FIRE SAFETY INSPECTION REPORT

SAMS ATTIRE LTD.

**BHUIYAN TOWER, PLOT NO. 10, ASHULIA JAMGORA,
SAVAR**

March 23, 2014

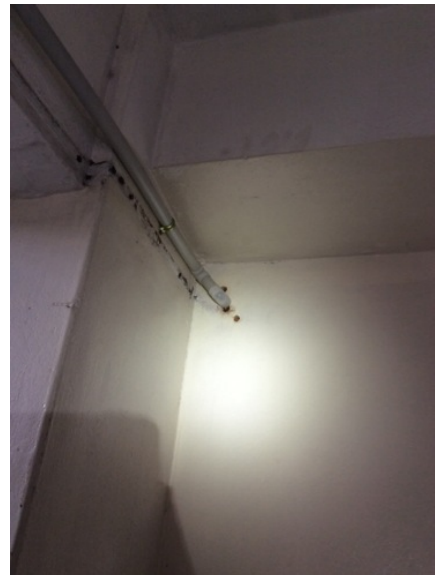
F-3	Fire Rated Construction	The ground floor bonded warehouse is not separated by fire-rated construction due to non-rated doors and unprotected openings. The storage room currently discharges to the southwest stairwell through an unprotected vestibule.	Provide the bonded warehouse separation by minimum 1-hr fire-rated construction. Provide the vestibule with a 1-hr fire-rated door to the warehouse and a 1.5-hr fire-rated door to the stairwell.	Within 3 months
-----	-------------------------	---	--	-----------------

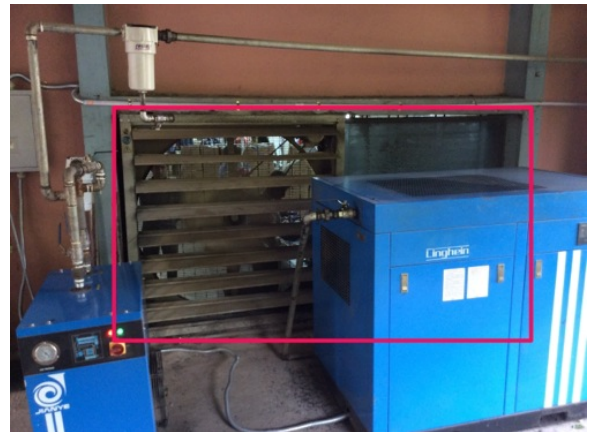
F-6	Fire Rated Construction	The boiler rooms on the first and second floors are not separated by fire-rated construction due to openings (to factory floor and the exterior of the building), non-rated doors, and penetrations.	Separate the boiler rooms by a minimum 2-hr fire-rated construction. Seal and/or protected all openings to maintain the required fire separations	Within 3 months
-----	-------------------------	--	---	-----------------

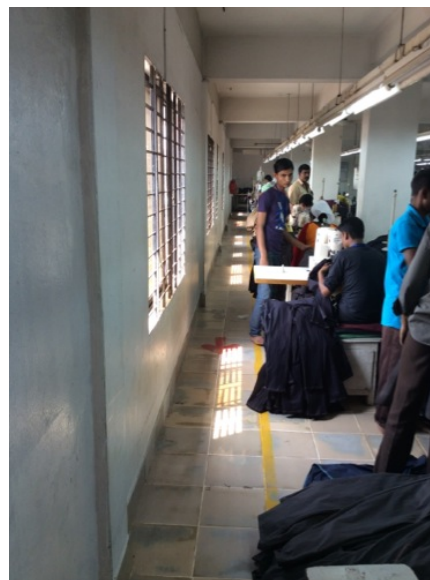
F-18	Egress	The width of egress aisles is less than 36-in. in various locations throughout the factory.	Provide minimum aisle widths of 36-in.	Within 3 months
------	--------	---	--	-----------------

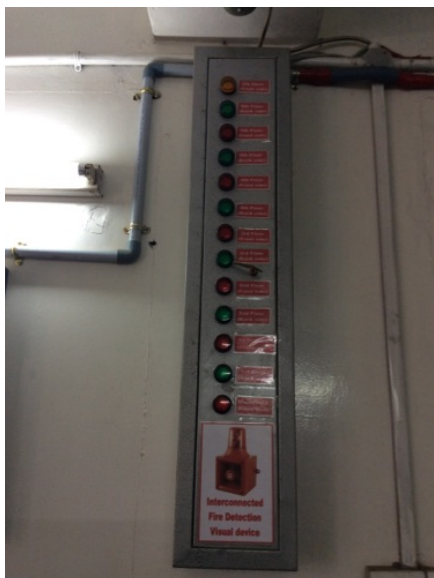
F-20	Fire Protection	The fire alarm system is antiquated, not a listed system, and does not provide alarm and notification features consistent with acceptable standards.	Replace the fire alarm system with a new, listed addressable fire alarm system in accordance with NFPA 72.	Design within 4 months, install within 9 months
------	-----------------	--	--	---
